Title: **Text replacements in Clause 14 to include 3 Mbit/s FH PHY**

Date: May 1996

In document P802.11-96/52 the extension of the current FH PMD to support an optional 3 Mbit/sec rate was presented. This submission presents proposal for text replacements in the Clause 14.

Figure C, 4 Level GFSK Transmit Modulation

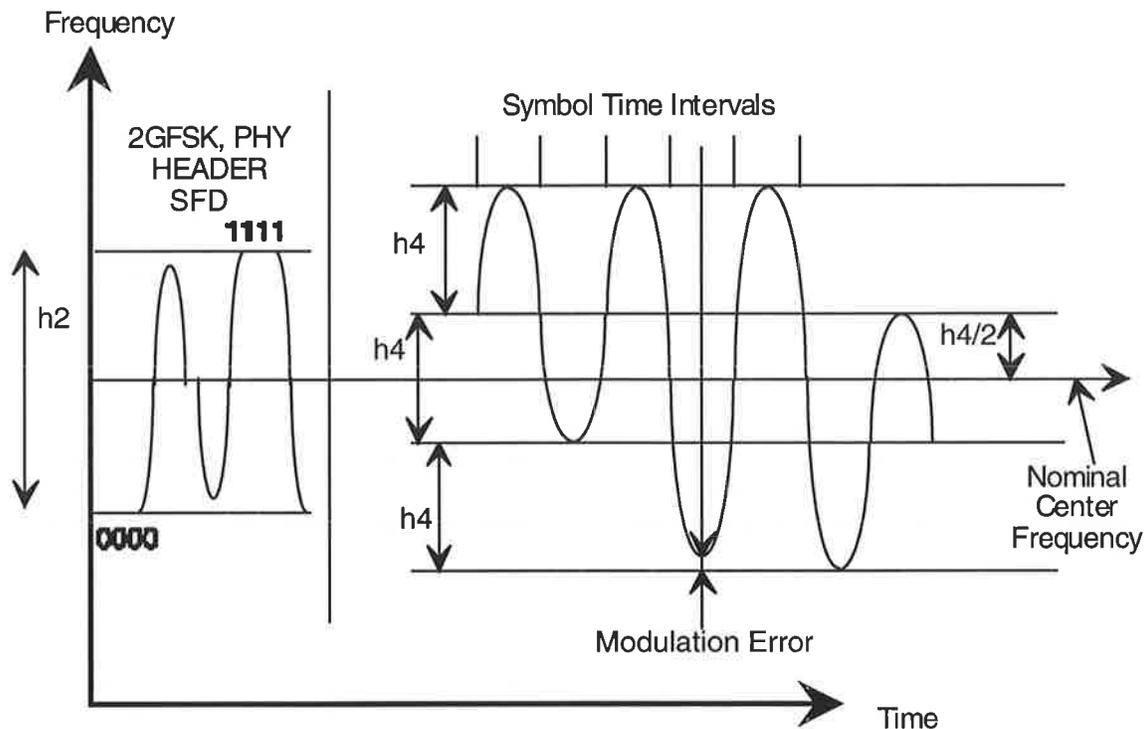
The modulation error shall be less than +/- 15 kHz or 8 kHz at the mid symbol time for 4-GFSK and 8GFSK, respectively, from the frequency deviations specified above, for a symbol surrounded by identical symbols, and less than +/- 25 kHz for any symbol. The deviation is relative to the actual center frequency of the RF carrier. For definition purposes, the actual center frequency is the mid frequency between symbols 11 and 01 for 4GFSK and between 001 and 101 symbols for 8GFSK. The actual center frequency shall be within +/- 60 kHz of the nominal channel center frequency defined in subclause **Error! Reference source not found.** and shall not vary by more than +/- 10 kHz/msec, from the start to end of the PLCP_PDU. The peak-to-peak variation of the actual center frequency over the PLCP_PDU shall not exceed 15 kHz. Symbols and terms used within this subclause are illustrated in the Figure C below:
